Peach Bottom Atomic Power Station, Units 2 and 3  
Renewed Facility Operating License Nos. DPR-44 and DPR-56  
NRC Docket Nos. 50-277 and 50-278

Subject: License Amendment Request to Revise Technical Specifications 3.8.4, DC Sources - Operating

**Subject: License Amendment Request to Revise Technical Specification 3.8.4,  
DC Sources - Operating**

**125 VDC Control Power to EDGs & 4KV Buses**

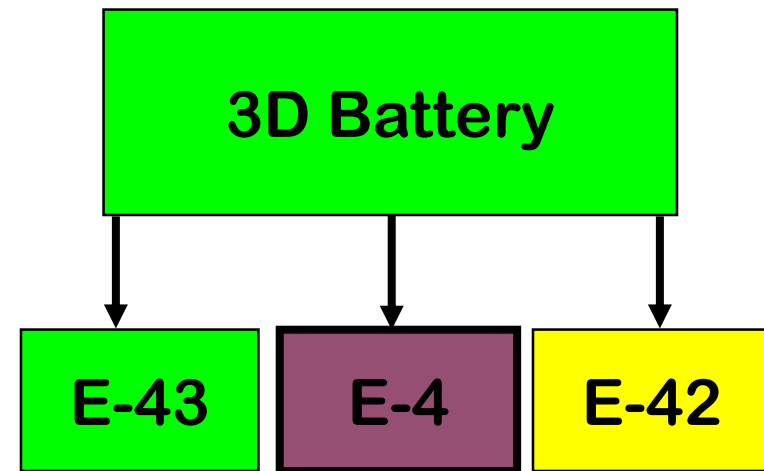
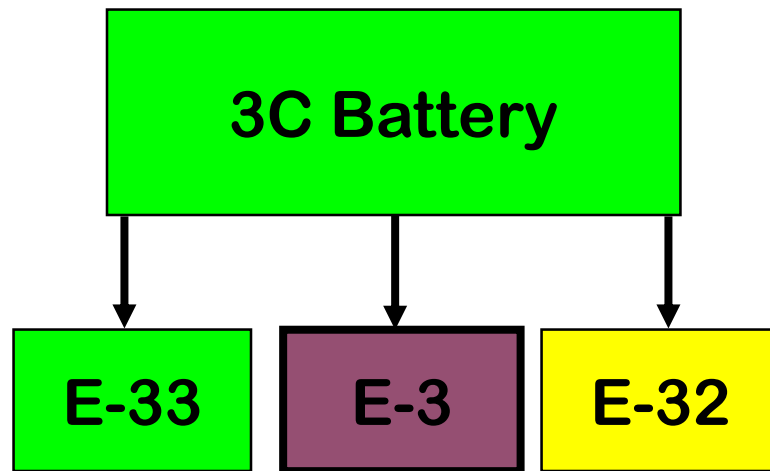
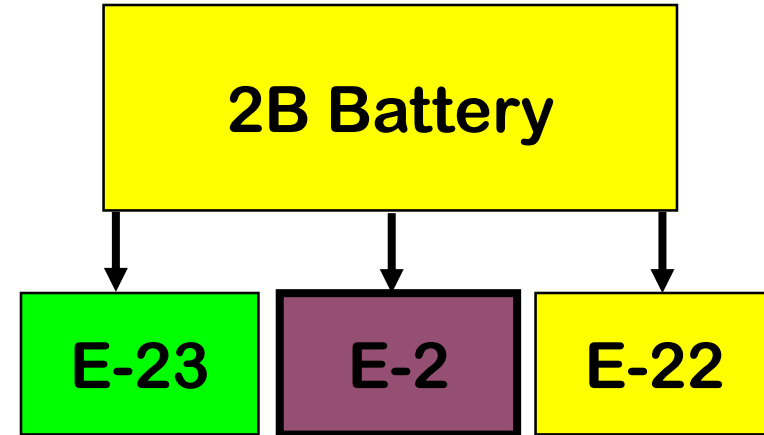
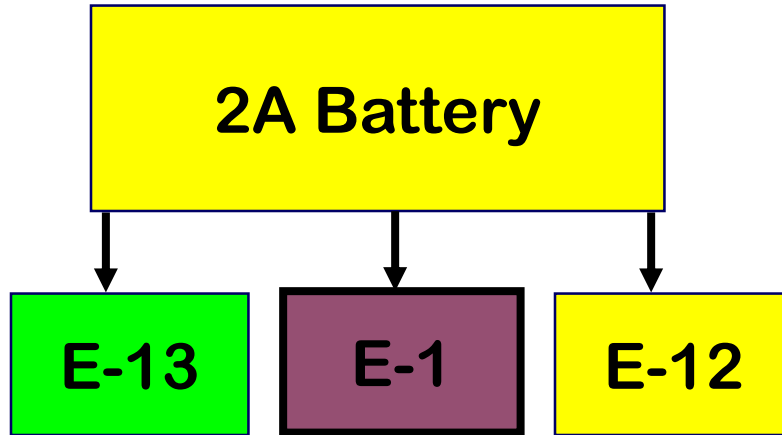
The above inter-unit DC electrical power subsystem relationships are illustrated, at a simple block diagram level, in Attachment 4, “125 VDC Control Power to EDGs & 4KV Buses,” which helps to clarify and provide the bases for why inter-unit LCOs are required at PBAPS.
